MERCUISER SERVICE BULLETIN

Number: 66-2A 66-

Date : 3/1/66 03

- A. Power Tilt Hydraulic Hose Install. - MerCr. IA-IB-IC (P. 5 Sec. II)
- B. Tachometer Service and Replacement (Section II)
- C. Flame Arrestors - 4-and-6-Cyl. Engines (P. 15 Section VIII)
- D. Water Pump Housing Liner (PP 11 & 14D Section IX)

A. POWER TILT HYDRAULIC HOSE INSTALLATION - MERCRC. IA-IB-IC [Reprinted Bulletin]

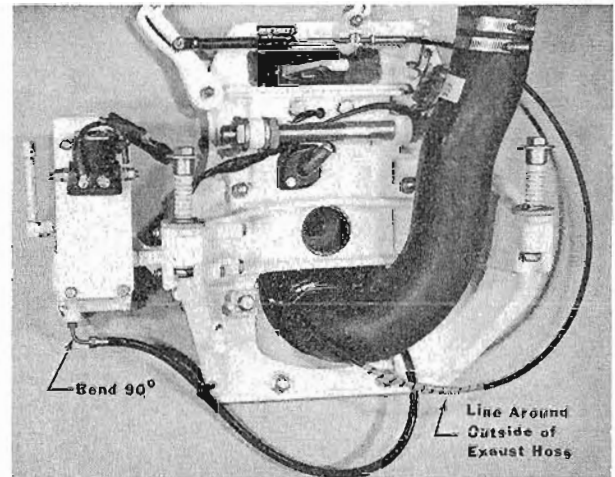
To eliminate possibility of engine coupling damaging hydraulic pump hose, the hose is routed around outside of exhaust hose. (Figure 1)

On new installations, or when replacing hydraulic hose, it is important that hose be installed as shown in figure on right.

Hydraulic pump hose, which may be damaged when installed other than as shown, right, cannot be covered under the factory warranty policy.
